ECE/TRANS/WP.29/GRSP/2005/5/Rev.1
3 March 2006

REVISED PROPOSAL FOR DRAFT AMENDMENTS TO REGULATION No. 16
(Safety-belts)

Transmitted by the expert from France on behalf of the ad hoc group

DESCRIPTION OF CURVE OF TROLLEY' S, DECELERATION OR ACCELERATION,
 AS FUNCTION OF TIME

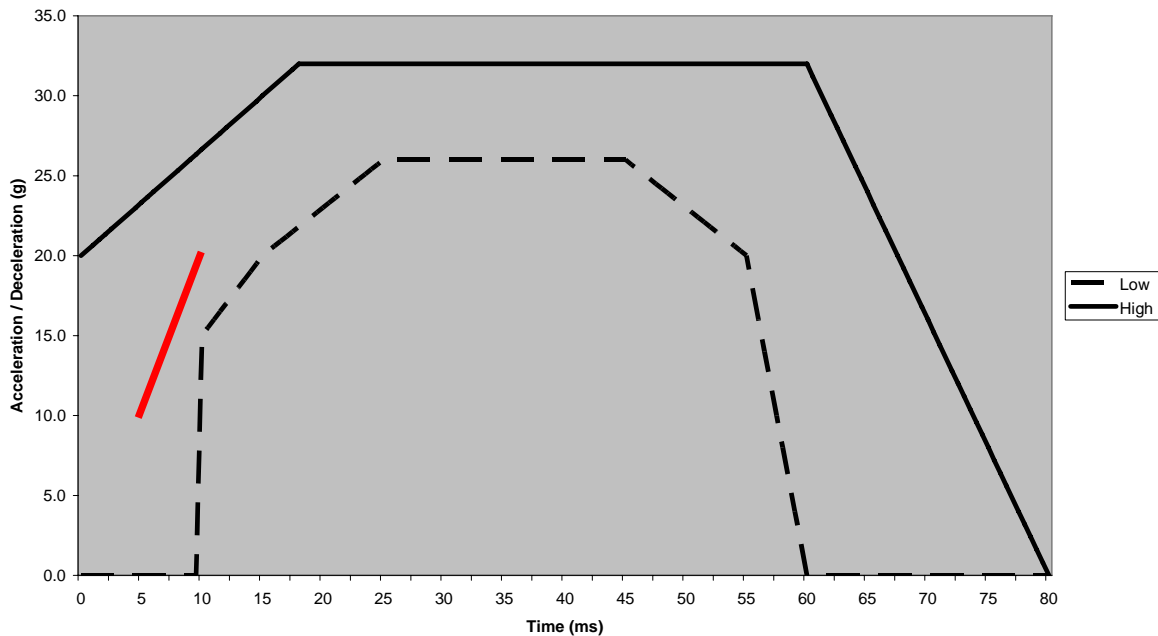
Annex 8, amend to read:

Parts of Annex 8 have been put in paragraph 7.7.4. in order to use the same Annex 8 for the two test devices (acceleration and deceleration).

As it can be seen in the table below, the actual pulse corridor permits a wide range of velocity change if there is no defined impact speed.

It is for that reason that a velocity change of 51 km/h has been defined for the acceleration test device. This variation of speed corresponds to the nominal curve and also to actual variation of speed on deceleration test devices including impact speed plus rebound speed.

The trolley shall be so propelled that, during the test, its total velocity change ΔV is $51 \text{ km/h} \begin{matrix} +2 \\ -0 \end{matrix} \text{ km/h}$ and its acceleration curve is within the hatched area of the graph in Annex 8, and stay above the segment defined by the coordinates **10g, 5ms** and **20g, 10ms**. The trolley shall remain horizontal during the **acceleration**. **The start** of the impact (T0) is defined, according to ISO DIS 17 373 for a level of acceleration of 0.5 g.
